APPLICATION: A. Special Permit to allow a fast food restaurant in the SC-PUD zone

South west corner Truxel Road and San Juan Road

Re: P86-352

SUBJECT: Revised Conditions - Special Permit (P86-352)

# SITE PLAN

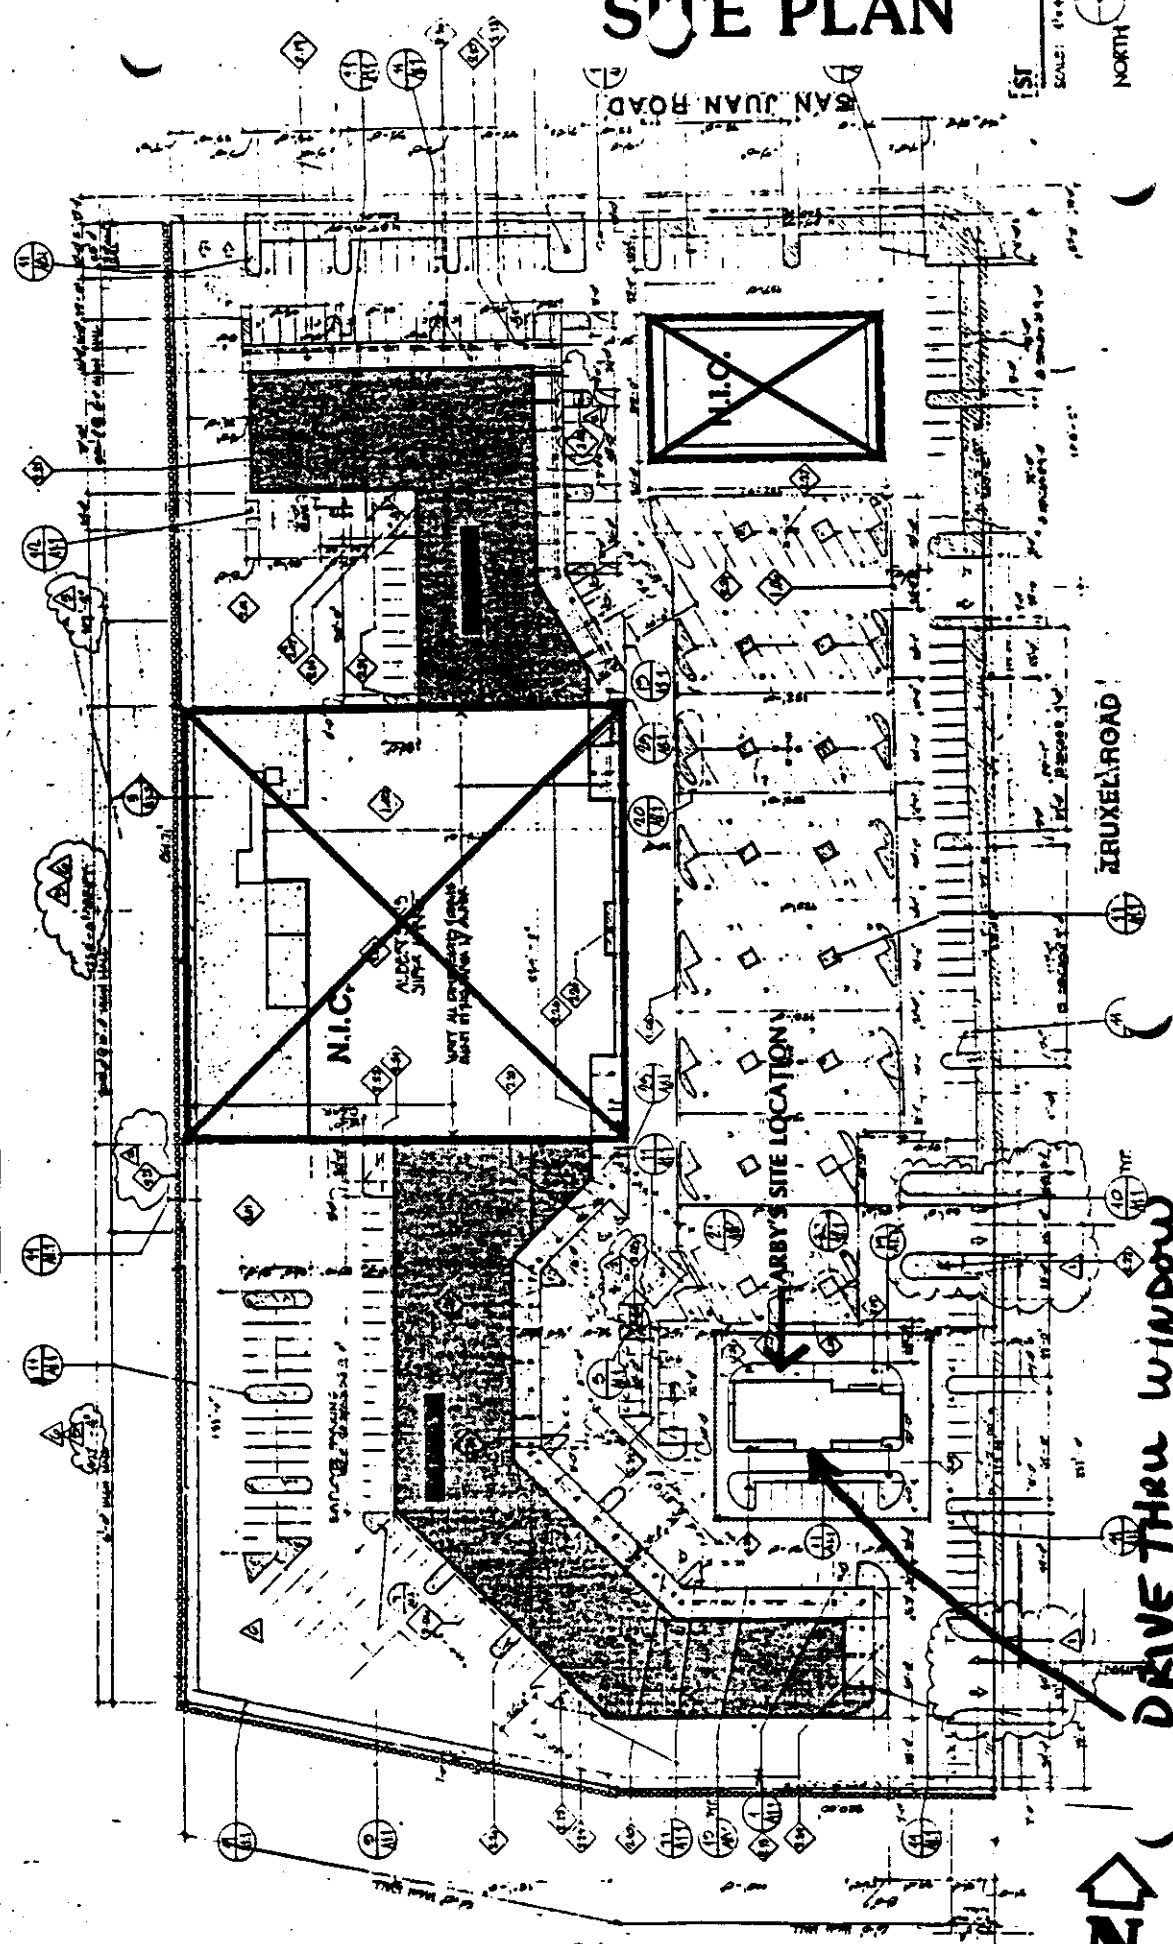
Traffic Engineering: The drive-thru area has adequate stacking distance to accommodate five cars simultaneously. Therefore, traffic has no problems with the project as proposed.

# ELEVATIONS

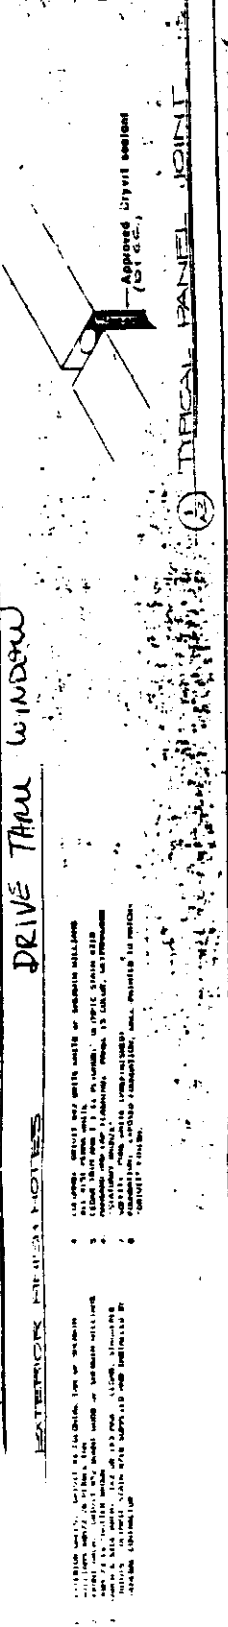
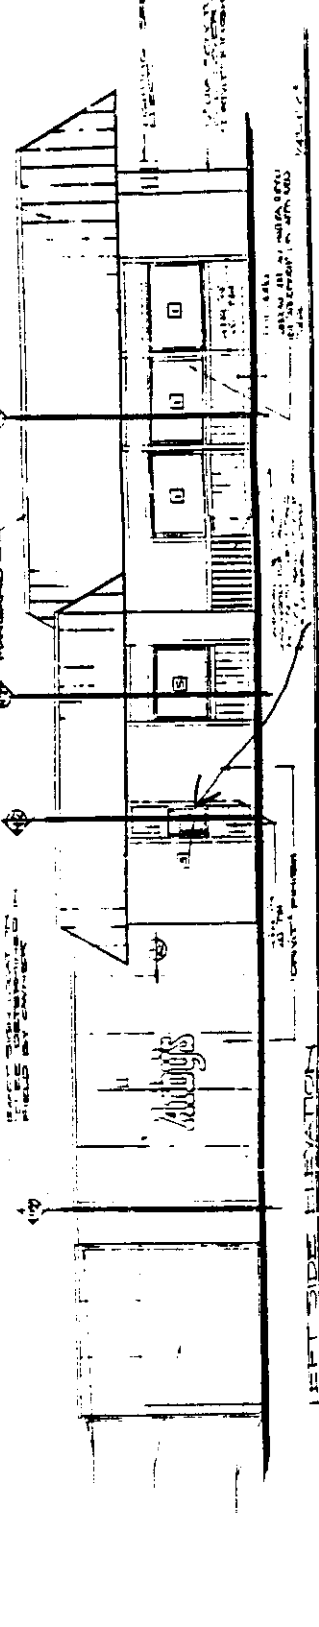
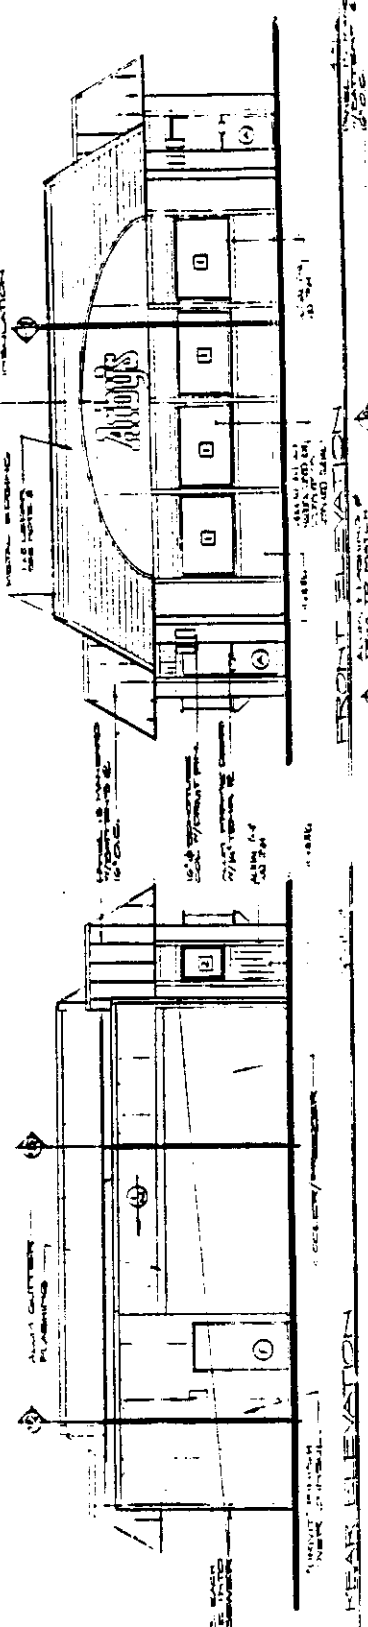
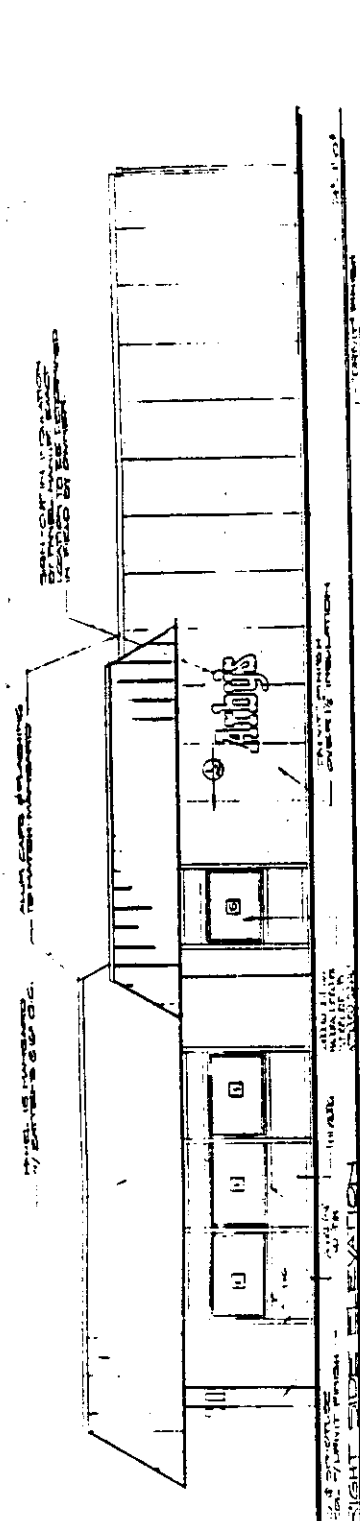
6. Exposed beams underneath the mansard roof should be added to all elevations to match the exposed beams as constructed on the existing shopping center. These exposed wood beams shall be placed under all mansard roof areas, except the area over the greenhouse.
7. The two mansard roofs on the west elevation shall continue all the way across the west roof line so as to give architectural continuity to all sides of the building.

Staff has the following comments regarding the proposed elevations and exterior building materials:

1. Drivit or stucco may be used along the east elevation above the greenhouse window area only. For the remainder of the east elevation and all other elevations, staff recommends using split face concrete block only to match the existing shopping center.

2. An exterior wood trellis shall be added to the west, south and east elevations on all walls not located below the mansard roof. The trellis support columns shall be constructed of wood. These wood trellises will provide additional design variation.

3. All air-conditioning equipment shall be hidden behind the mansard roof.
4. The mansard roof shall be red tile to match the roofs of other buildings in the shopping center.

5. The two proposed 16" sonotube columns on the east elevations indicate they will have a drivit finish. Staff recommends only split face concrete block, to match the existing shopping center columns be used for the proposed sonotube columns.

3. The applicant shall develop planter areas as proposed (see landscape plans).
4.
  - a. Split face concrete block to match that of the shopping center shall be used on the exterior wainscot on all walls of the building.

- b. Mansard roof to have tile to match shopping center in color and shape.
  - c. Mansard roof to extend around building. All air-conditioning equipment shall be hidden behind the mansard roof.

- d. Flat arched sign area to be removed from mansard roof at front elevation.
  - e. The rear elevation of the higher mansard roof is to be carried across the building from the right to left side.

- f. The two round columns at the front elevation to be changed to columns to match those found on the shopping center in shape and finish.
  - g. No T1-11 to be used on the exterior of the building.
